Re: Redtail Winery Traffic Impact Study Report – Responses to Peer Review and County Comments

TraffMobility Engineering Inc. (TraffMobility) prepared a Traffic Impact Study Report dated December 6, 2024 (December 2024 Report) in support of the site plan control process for the proposed Redtail Vineyard development on Loyalist Parkway, Prince Edward County (County), Ontario.

Paradigm Transportation Solutions Limited (Paradigm) was retained by the County to conduct a technical review of TraffMobility's December Report. Findings and recommendations from Paradigm's technical review, dated January 14, 2026 (January 2026 Review Letter) are documented in this letter along with our responses.

Access Sightline Analysis

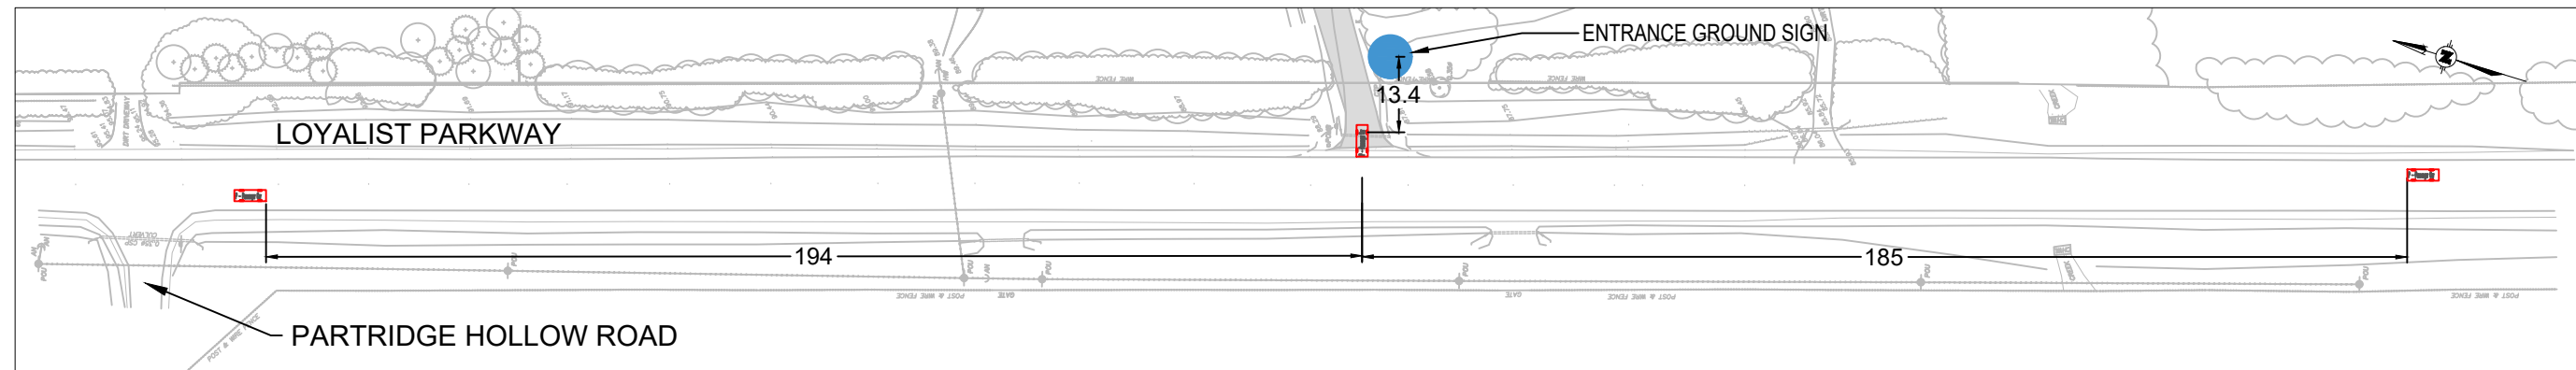
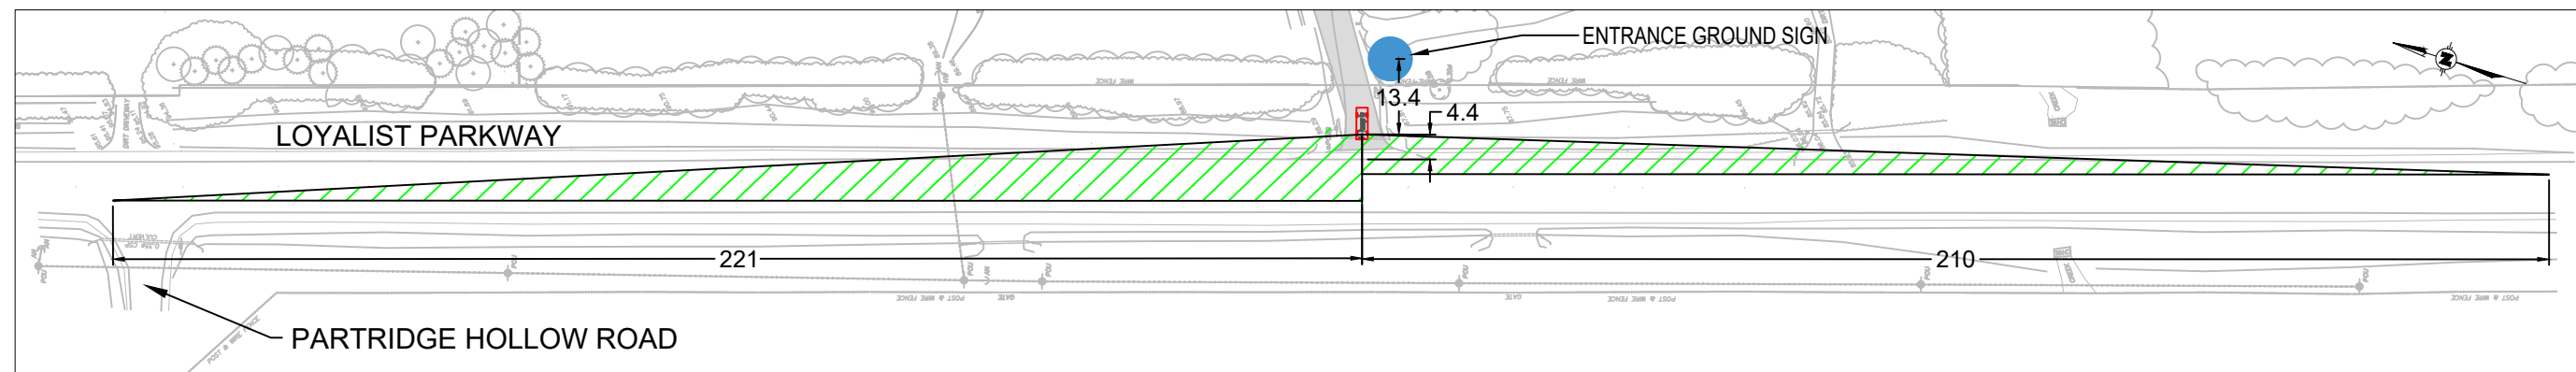
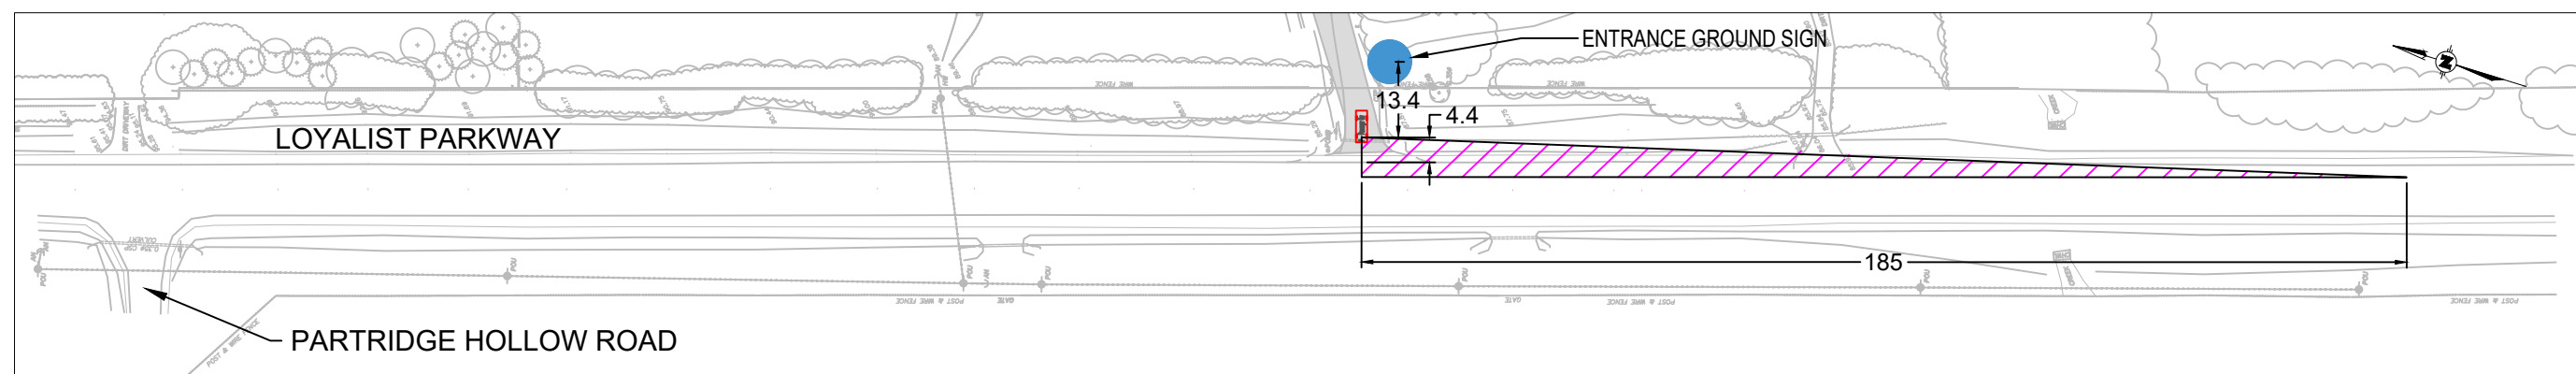
While acknowledged in the 2021 Traffic Brief for the initial development proposal for the subject site, the potential effect of the relatively steep Loyalist Parkway downhill grade to the north of the subject site was not accounted for in the current TIS.

The intersection sight distance analysis and the design details (parallel lane and taper lengths) for the recommended southbound left turn lane at the Loyalist Parkway/Site Access intersection should be reviewed by the consultant to determine if the downhill grade on Loyalist Parkway to the north of the Site Access would have any effect on the feasibility of the design.

Please ensure that ground sign is outside of the sight triangle prescribed under the Zoning By-law.

Please verify whether the grade of Loyalist Parkway will impact sightlines and require changes to the cross section. If the entrance location/common element location changes as a result, this should be reflected on the Draft Plan of Condo.

The design requirement for intersection sight distance for passenger cars from the TAC manual and the available sight distance from the site plan are summarized in **Table 4** with adjustment of 5% increase to account for the approach downslope grade between 3% and 4% for the stopping sight distance and left turn sight distance. The results show that the proposed site access has adequate sight distances for a design speed of 100 km/h when accounting for grade. The access sightline analysis is provided in **Attachment 1**.

The ground sign is located outside the sight triangle as shown in **Attachment 1**.

The grade of Loyalist Parkway will not impact sightlines and changes to the cross section are not required. Refer to Peer Review **Comment #7** response for additional details on sightlines.

Vehicle Manoeuvring Diagrams

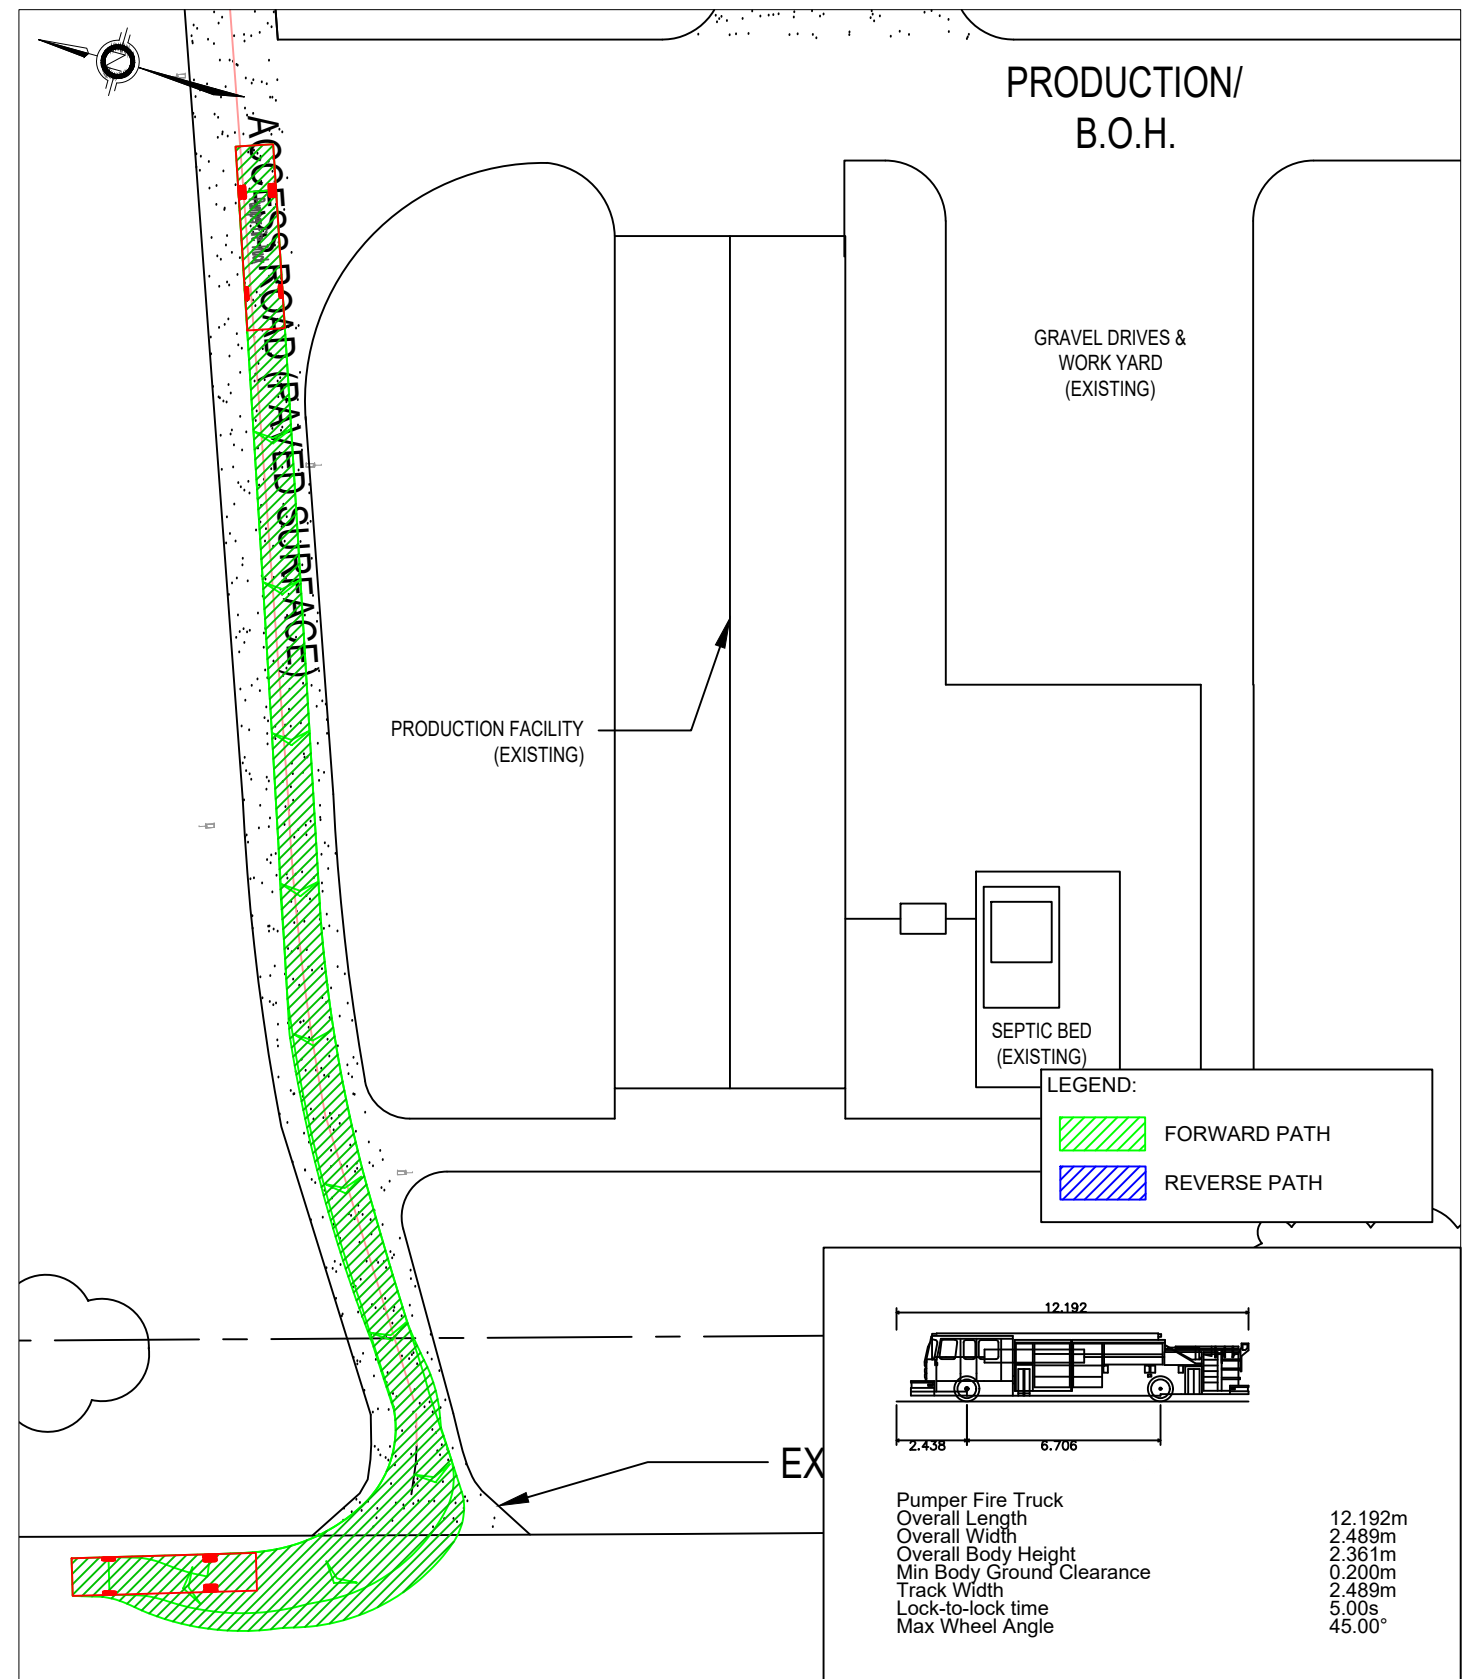
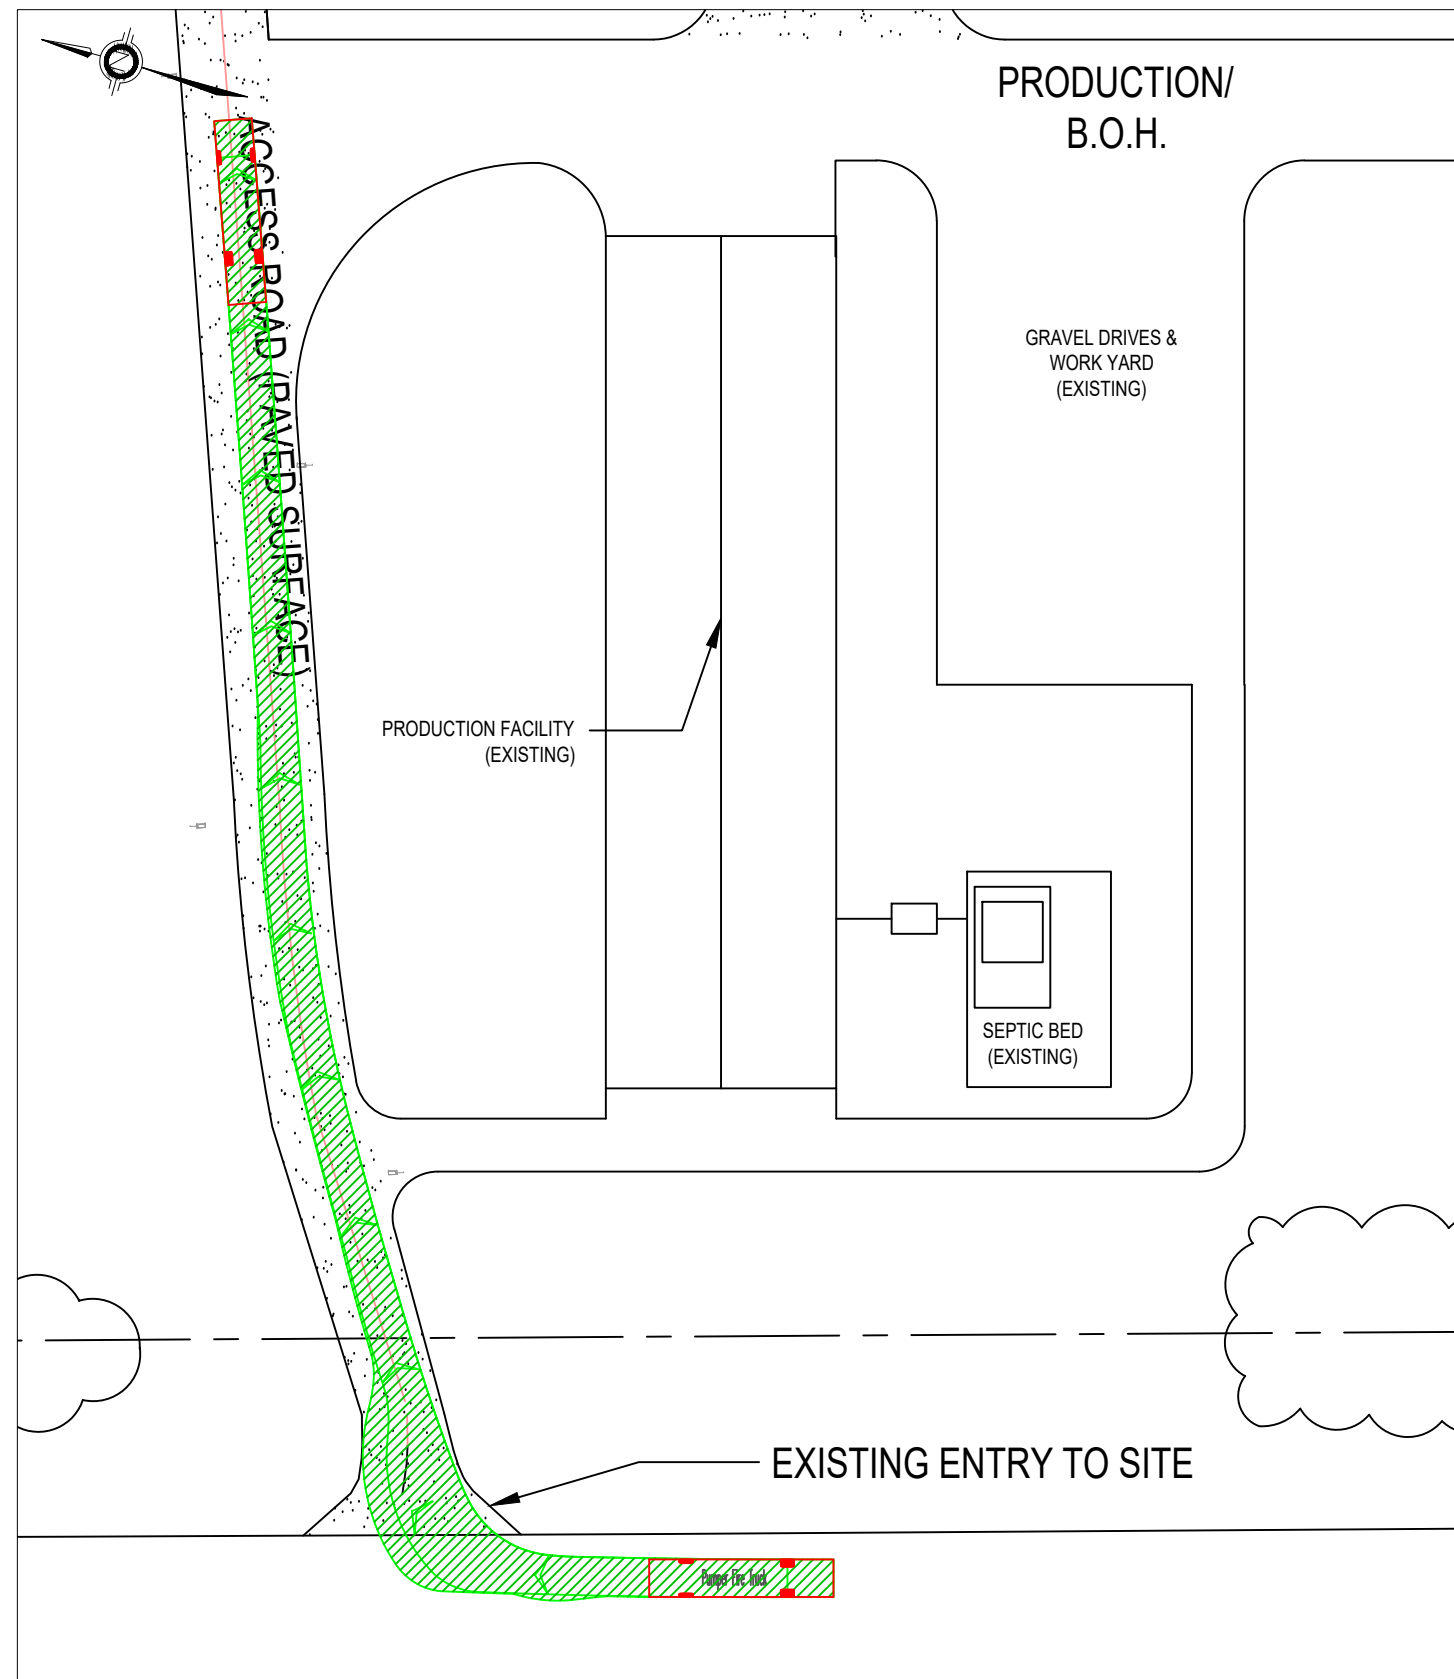
It was noted that the 2021 Traffic Brief did include a report section regarding emergency access and circulation requirements, but this was not included in the current TIS.

County staff should confirm the sufficiency of the proposed parking supply relative to the Zoning By-law and the adequacy of the proposed site plan as related to emergency access and circulation.

Please indicate width of entrance on the cross section and verify that the entrance/internal road network can accommodate emergency services per within the Traffic Impact Study Addendum Letter. For reference, emergency service standards are outlined in By-law 3121-2012.

Additional pumper fire truck swept paths are provided in **Attachment 2** which demonstrated that a fire truck can enter and exit the site at Loyalist Parkway.

This recommendation is directed to County staff for consideration. Additional pumper fire truck swept paths are provided in **Attachment 2** which demonstrated that a fire truck can enter and exit the site at Loyalist Parkway.

The entrance width is 6 m and can accommodate a pumper fire truck. Additional pumper fire truck swept paths are provided in **Attachment 2** which demonstrated that a fire truck can enter and exit the site at Loyalist Parkway.
